HINCKLEY NATIONAL RAIL FREIGHT INTERCHANGE

The Hinckley National Rail Freight Interchange Development Consent Order

Applicant's response to ExA Written Questions

Document reference: 20.1

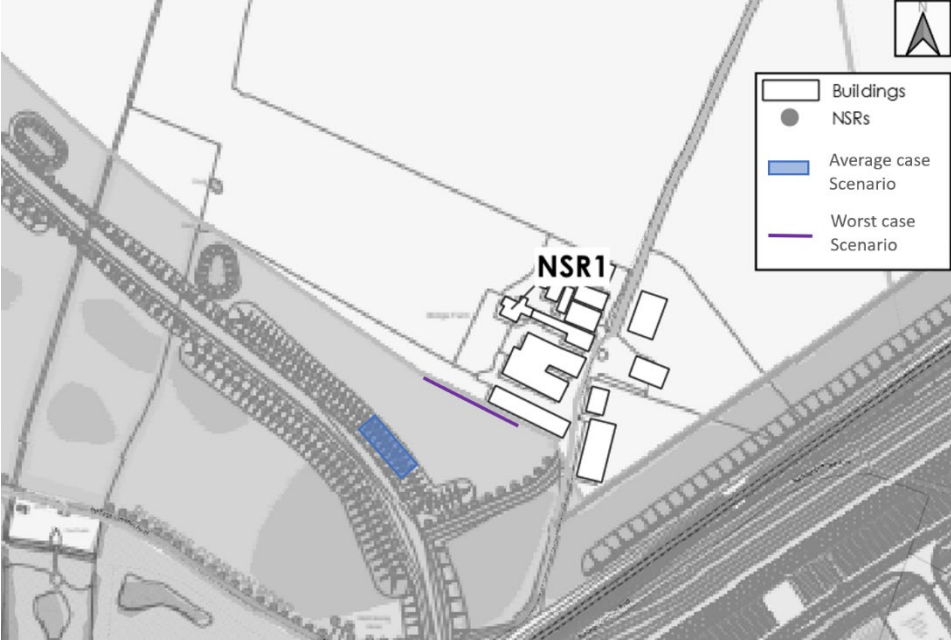
1.7.35.	The Applicant	<p>Market Needs Assessment [APP-357] – Need calculation</p> <p>Please confirm whether the calculation of need is 1.6Mm2 or 768,000m2, after taking into consideration of existing commitments and planned provision.</p>	<p>The Applicant confirms that there is a shortfall of 768,000 m2 (307 ha) at rail served sites which should be planned for (including margins) after taking into consideration existing supply. This is detailed in Document reference: 18.8.4 (REP3-068) paragraph 1.18, 2nd bullet.</p> <p>This figure is from the ‘Warehousing and Logistics in Leicestershire and Leicestershire: managing growth and change’ (attached as Appendix 2 to Document reference: 18.8.4 (REP3-068)) on behalf of the local planning authorities in Leicester; Leicestershire County Council and the Leicester and Leicestershire Local Enterprise Partnership. Inevitably this report is ‘project blind’ in that it relates to the generic subregional need for larger B8 units over 9,290 m2 across Leicestershire.</p> <p>Document reference: 18.8.4 (REP3-068), paragraph 1.19 references the Statement of Common Ground on Planning Matters with the LAs for HNRFI it has been agreed:</p>

ExQ	Question to:	Question	Response
			<ul style="list-style-type: none"> • That the Study above identifies a short fall of 718,875 m2 of rail served sites which should be planned for the period to 2041 – and that a supply shortfall for rail served sites ‘starts to emerge around the mid 2020’s (Leicester and Leicestershire Authorities’ ‘Statement of Common Ground relating to Strategic Warehousing and Logistics Needs’ attached as Appendix 3 (September 2021 paragraphs 3.4-3.5).
	The Applicant	<p>Geographies of Market Areas Plan [REP3-067]</p> <p>The plan, as submitted, does not identify the rail line as part of the physical geography, could the Applicant revise the plan to highlight this and change the reference from miles to kilometres.</p>	The revised plan is submitted at Deadline 4 (document reference 18.8.3A).

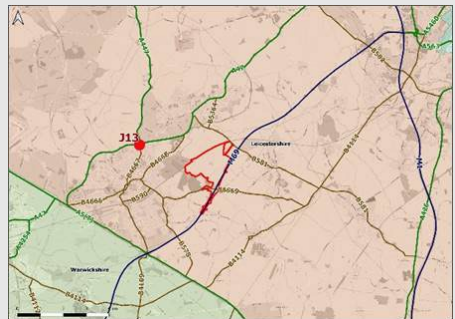
1.10.2.	The Applicant	<p>Topsoil</p> <p>a) What is the maximum amount of time that any section of topsoil would be set aside for re-use on site landscaping or stored for other off-site purposes?</p> <p>b) How much topsoil will be taken off-site for purposes such as Biodiversity Net Gain?</p>	<p>a) The maximum time that any section of topsoil will be set aside for reuse would be 24 months. Topsoil which does not have further reuse within the site, or as a temporary protection for earthworks plateaus, will be removed from site when it is generated and reused off-site for purposes such as creating and enhancing and creating additional Biodiversity Net Gain (BNG) sites such as restoring brownfield sites such as quarries and redevelopment of old industrial sites, via the CL:AIRE DoW CoP.</p>

ExQ	Question to:	Question	Response
		<p>c) How many vehicular movements will this result in?</p> <p>d) Could the Applicant please confirm whether this has been considered in all relevant assessments?</p>	<p>b) As detailed within paragraph 16.106 of the ES Chapter 16 (document reference: 6.2.16, APP-125) the organic topsoil material volumes can be minimised by measurement of organic content of soils with depth. This will minimise the volumes stripped and becoming ultimately surplus to requirement within the development. We anticipate that all the surplus topsoil will be reused for purposes such as BNG and land reclamation, improvement purposes. The volume of topsoil to be taken off-site is set out in response to (c) below.</p> <p>c) The surplus topsoil that we cannot reuse on the site, will typically be taken off site as 20T loads (12.5m³) in HGV tippers and with the volume of surplus topsoil anticipated at this stage to be 125,000m³ which will be removed at a rate of approximately 21 loads per week during the construction, with a peak of 160 loads per week. The topsoil will be removed when it is no longer required, which will be as the development progresses, as the development plateaus will be re topsoiled once they have been cut and filled to level and prior to the building works commencing to protect the plateaus and minimise the risk of dust and silt runoff. The surplus topsoil will be therefore removed from site over a period of 9-years, from the enabling works phase until the construction of the final building. However, if the topsoil is to be utilised reinstating a site within the locality of a suitable rail link, such as Croft quarry, the topsoil may be taken off site in later phases of the development by utilising the Rail Freight Terminal.</p> <p>d) The transport movements associated with the removal of this surplus topsoil from the site during the construction period has been allowed for in the modelling as set out in ES chapter 8 Traffic and Transport (document reference: 6.1.8A), ES Chapter 9 Air</p>

ExQ	Question to:	Question	Response
			Quality (document reference: 6.1.9, APP-118) and Chapter 10 Noise (document reference: 6.1.10A) and therefore no additional transport related effects arise through this process.
